REMARKS

This is a full and timely response to the outstanding Final Office Action mailed May 8, 2003. Claims 5, 6, 9, 12, 13, 15 - 19, and 22 have been cancelled without prejudice, waiver, or disclaimer. Claims 3, 14, 20, and 21 were previously canceled without prejudice, waiver, or disclaimer. Claims 1, 4, 7, 8, 10, and 11 have been amended. The subject matter of amended claims 1, 4, 7, 8, 10, and 11 is contained within FIGs. 4 – 13 and the related detailed description of the specification. Consequently, no new matter has been added. Upon entry of the amendments in this response, claims 1, 2, 4, 7, 8, 10, and 11 remain pending. Claims 1, 2, 4, 7, 8, 10, and 11 are patentable over the cited art of record. Reconsideration and allowance of the application and presently pending claims are respectfully requested.

AUG 21 2003 B FIG. 1 (Prior Art) 2

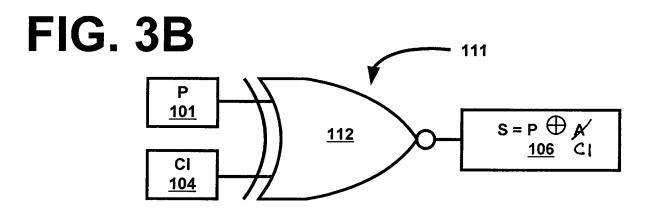
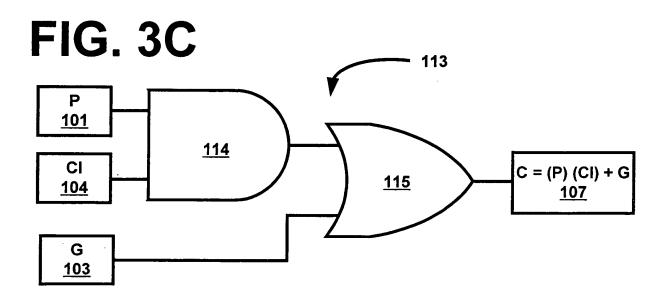
The Office Action indicates that FIGs. 1 and 2A-2D should be designated with a legend such as "prior art" because they are cited in the description of related art as a traditional encoding. Applicant has amended FIGs. 1 and 2A-2D to include the legend "prior art." Thus, the objection to FIGs. 1 and 2A-2D should be withdrawn.
